ORIGINAL ACRS-3121
OFFICIAL TRANSCRIPT OF PROCEEDINGS
NUCLEAR REGULATORY COMMISSION
ADVISORY COMMITTEE ON REACTOR SAFEGUARDS

Title: RELIABILITY AND PROBABILISTIC
RISK ASSESSMENT

DATE: Wednesday, June 28, 2000

The purpose of this meeting is to discuss the proposed final ASME standard for probably risk assessment for nuclear power plant applications.

The application process

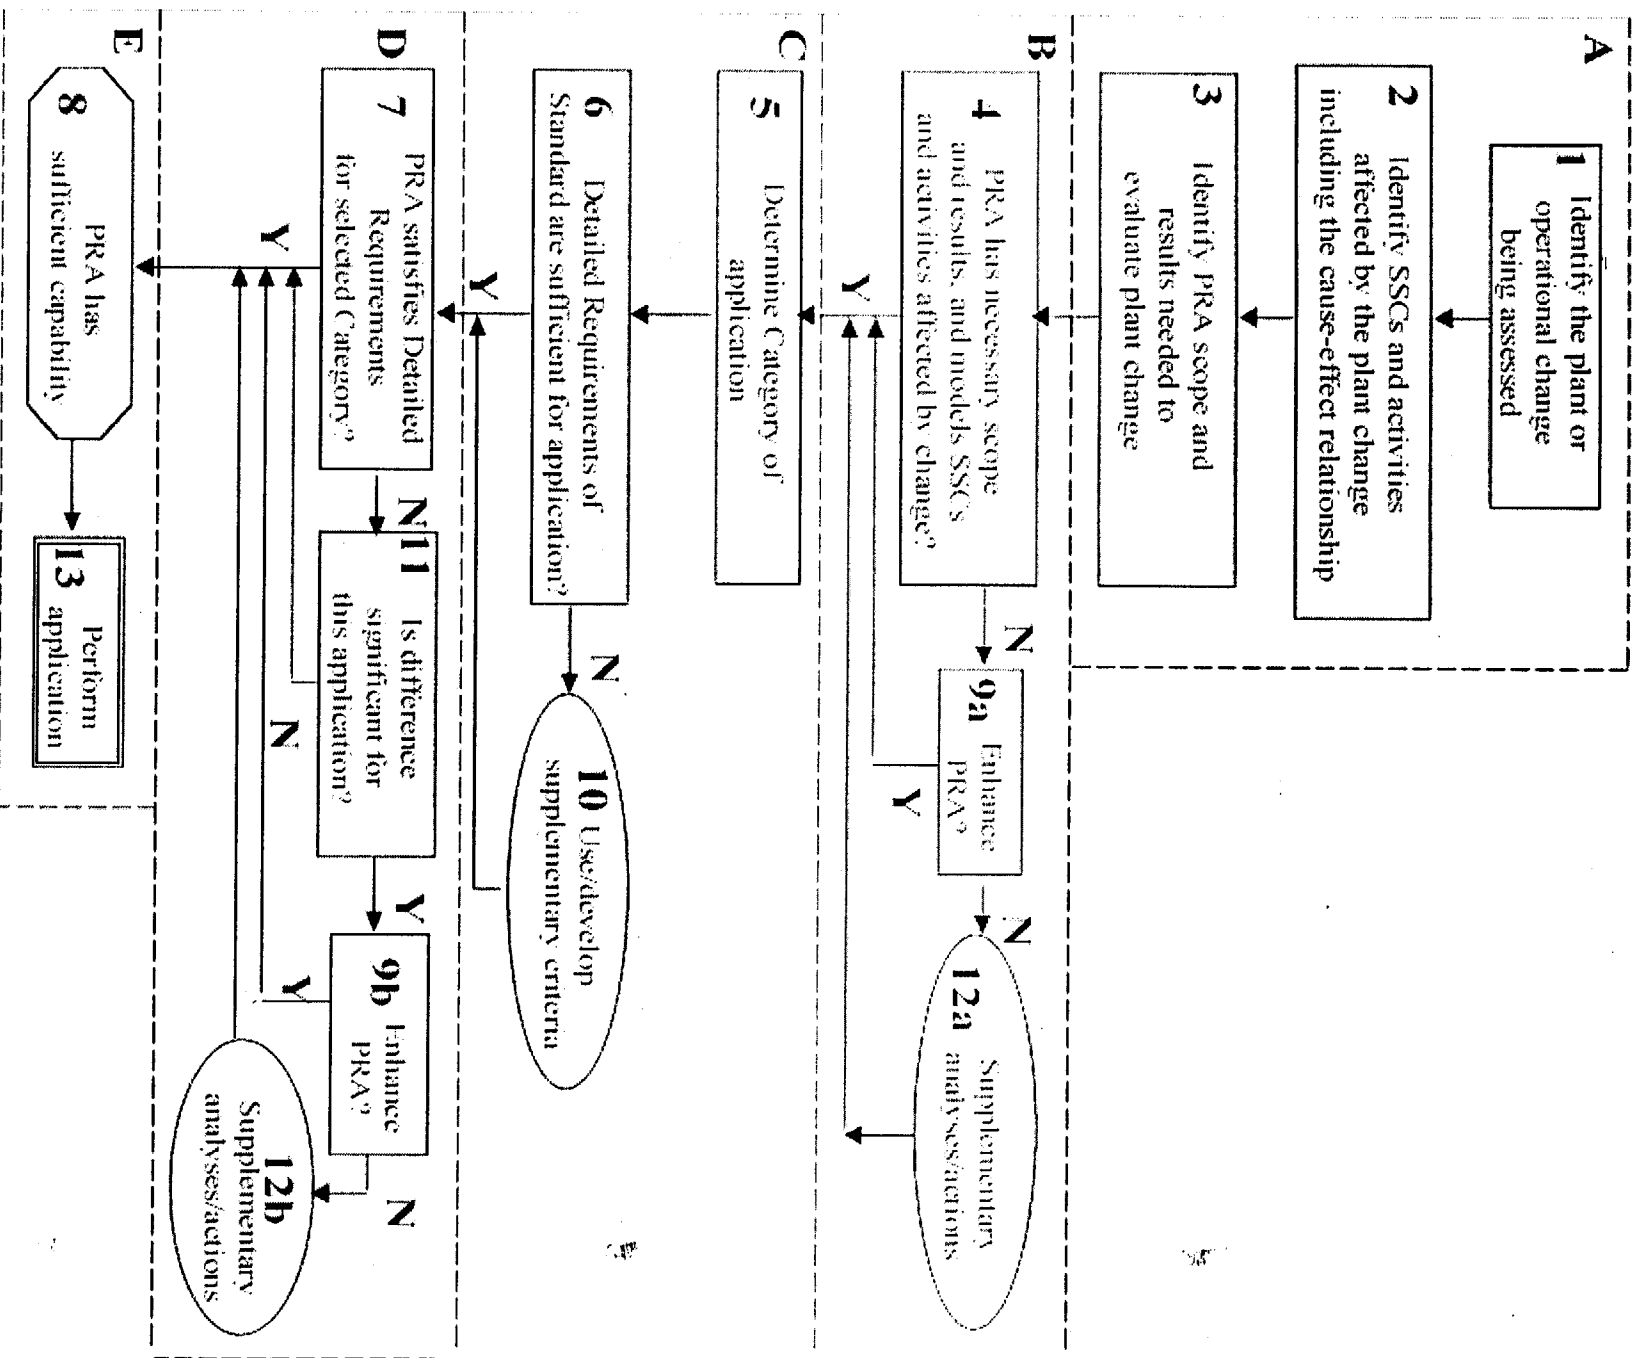
4 CHAIRMAN APOSTOLAKIS: So, how would you change
5 Box A?

6 DR. BONACA: I would not, maybe not change Box A,
7 but in the text where you have a description, in fact, of
8 how the steps are being done, there has to be a very clear
9 warning that there is always a risk in limiting your
10 projection of a model that you may miss something there.

3 CHAIRMAN APOSTOLAKIS: It is really Box C that you
4 comment is addressed --
